**RE: Marriott Suites at Winrock
2100 Louisiana Blvd.
Grading and Drainage Plan Stamp Date: 3/26/21
Hydrology File: J19D058I**

Based on the submittal received on 3/29/21, the Conceptual Grading and Drainage Plan is approved for Administrative Amendment and Grading Permit.

GRADING PLAN

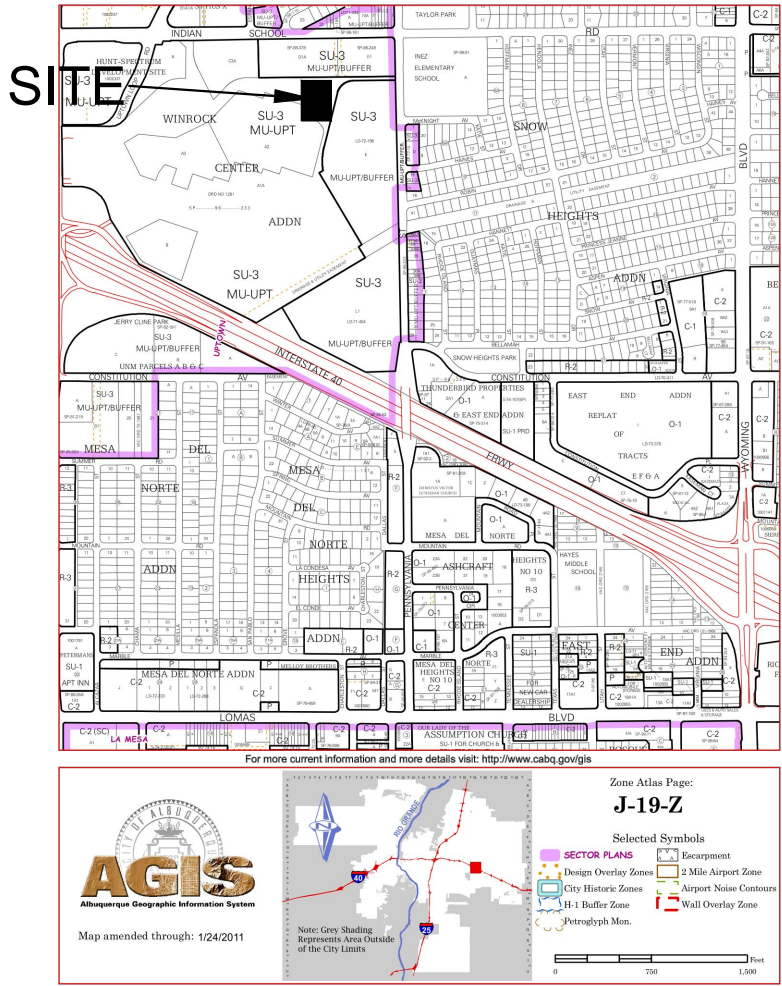
Per our discussions, the Stormwater Quality Volume (SWQV) required is 2,687 c.f. and you have accounted for 1,400 c.f. in the landscape islands. This leaves a total of 1,287 c.f. of SWQV to be accounted for with Payment in lieu. Payment in Lieu (Amount = 1,287CF x \$8/CF = \$10,296) of onsite management of the SWQV must be made. I have included an invoice for this amount with this letter.
